VIRGINIA ELECTRIC AND POWER COMPANY (DOMINION)
SURRY POWER STATION UNITS 1 AND 2
SURRY INDEPENDENT SPENT FUEL STORAGE INSTALLATION
REVISION TO SURRY POWER STATION EMERGENCY PLAN

ATTACHMENT 2
SURRY EMERGENCY PLAN REVISION 47 SUMMARY

Title: Surry Power Station Emergency Plan

COMMUNICATIONS LINKS
FIGURE 7.3

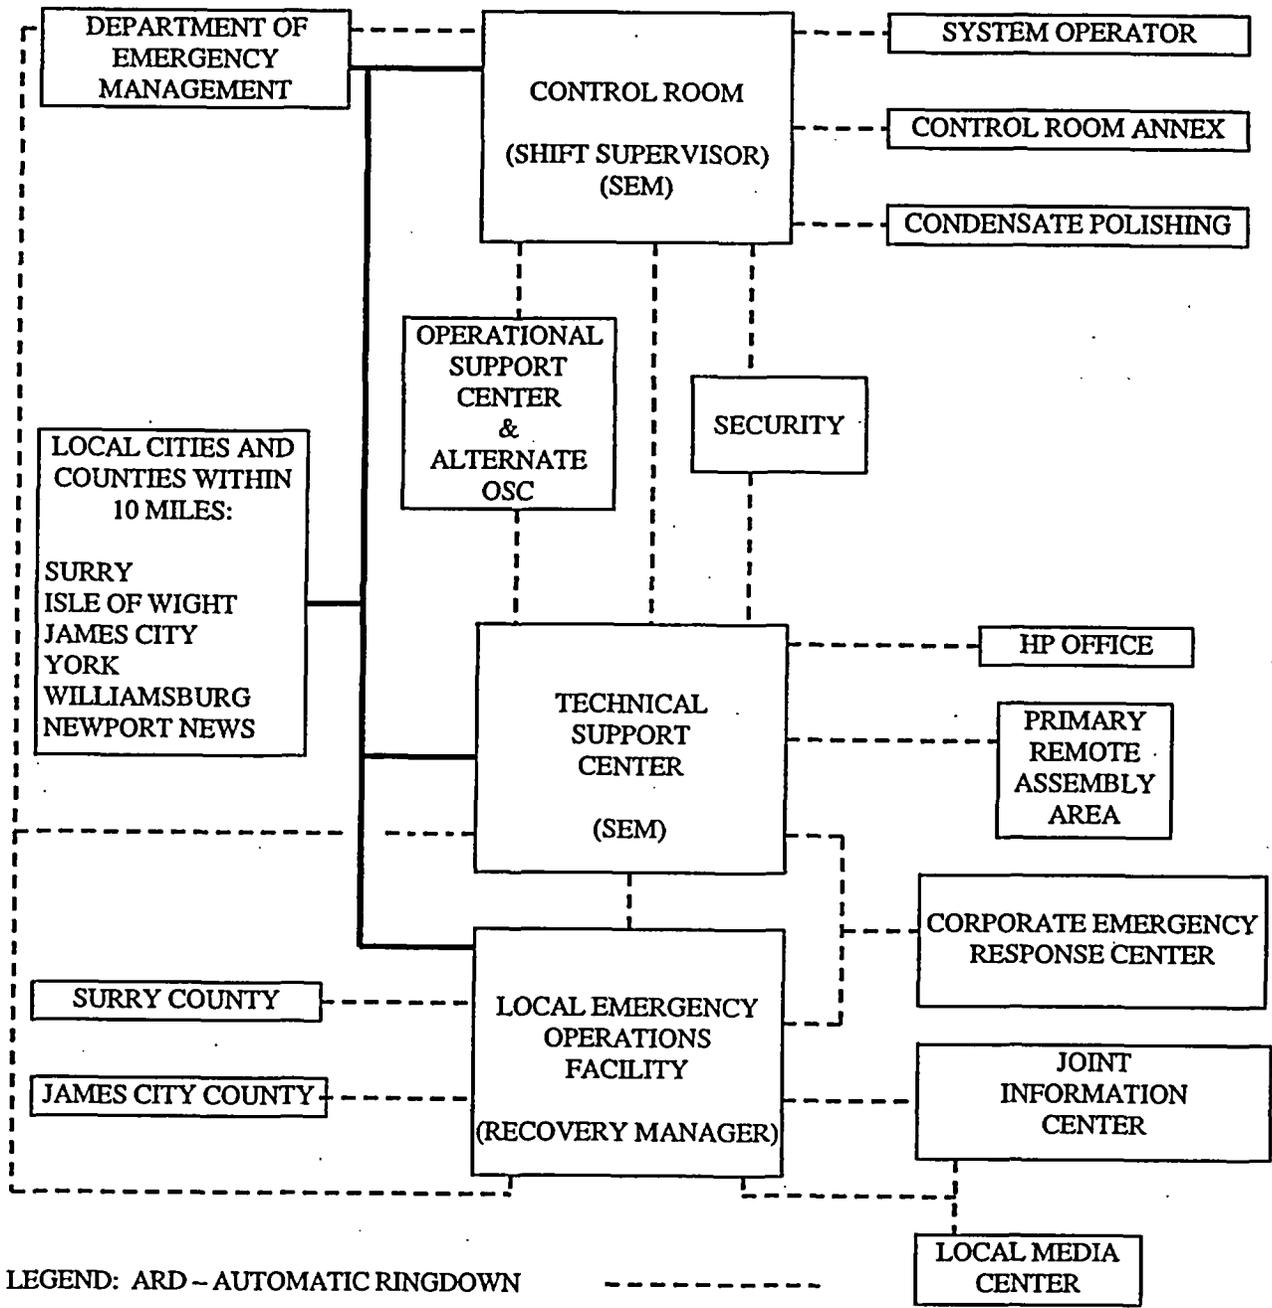
- References to the Joint Public Information Center (JPIC) updated to reference the Joint Information Center (JIC) per Corporate Emergency Response Plan Revision 10. (Section 1.1, Acronyms and Abbreviations, Section 5.3.1.5, Release of Information to News Media, Section 7, Table of Contents, Section 7.0, Emergency Facilities and Equipment, Section 7.1.6, Joint [Public] Information Center and Local Media Center, Table 7.1, ERF Communications, and Figure 7.3, Communications Links)
